Record of Decision
Peerless Photo Products Site
Town of Brookhaven, Suffolk County
New York
Site Number 1-52-031

DECLARATION STATEMENT - RECORD OF DECISION

Peerless Photo Products Inactive Hazardous Waste Disposal Site Town of Brookhaven, Suffolk County, New York Site No. 1-52-031

APC - 10 SOIL SAMPLING LOCATIONS

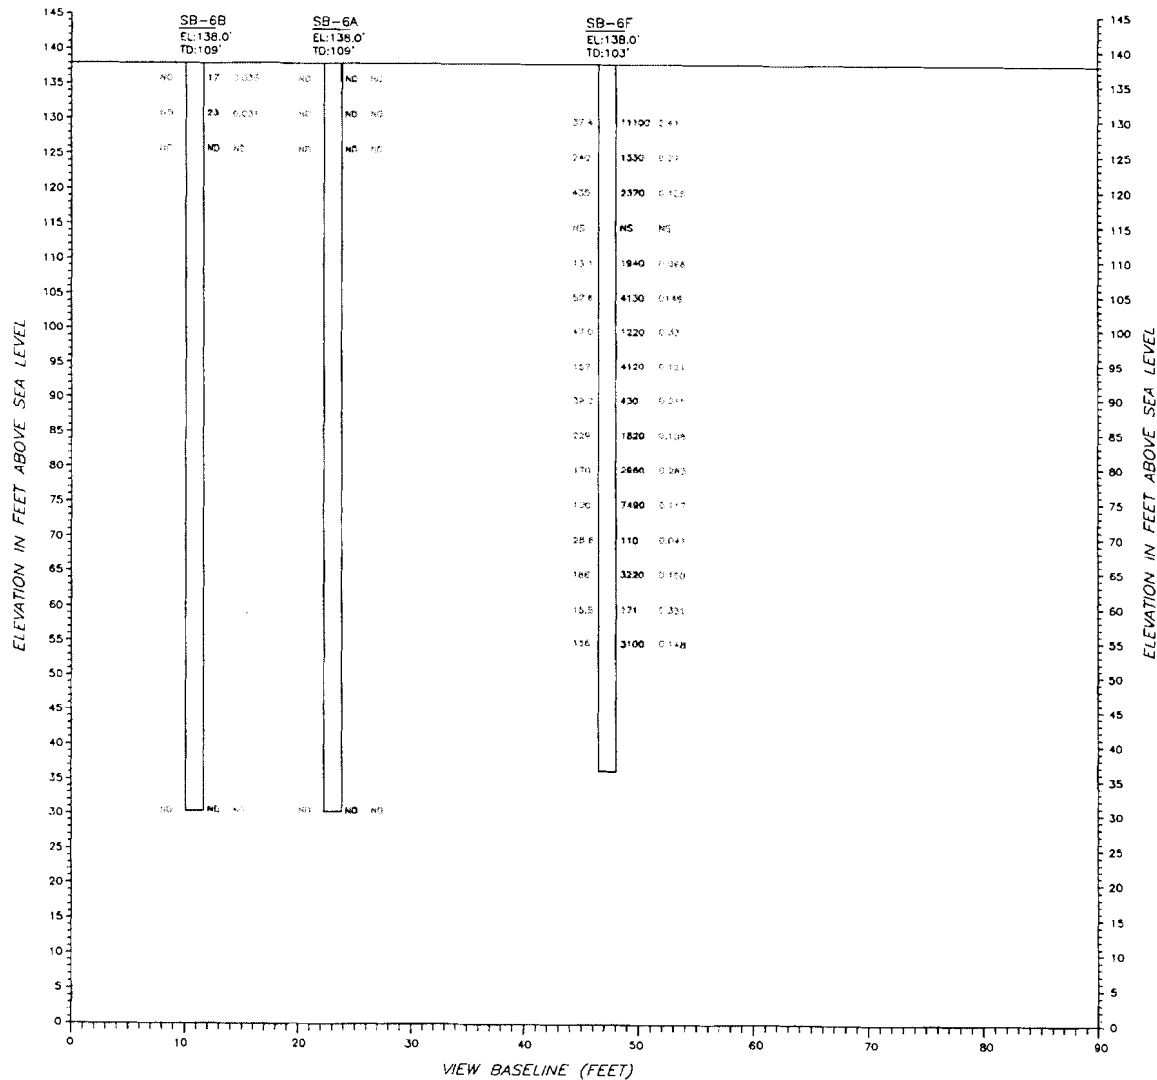
COMMENT 3: How will the tower base be excavated? What areas will be excavated inside of the tower base?

RESPONSE 3: Under the selected Alternative 3B, soils in a 20 feet diameter area, centered on the location of boring SB-6F, to a depth of approximately 30 feet will be excavated and disposed off-site. In situ stabilization will be used for soils from 30 feet to 100 feet below grade surface. The excavated area will be backfilled with clean fill.

RESPONSE 45: Soil Boring SB-6F was installed in the center of the Tesla Tower Base. Soil sampling results for SB-6F are also provided in the ROD. Please see Figure 5. The Tesla Tower Base area has been extensively investigated under RI/FS process. The State appreciates the historic information provided.
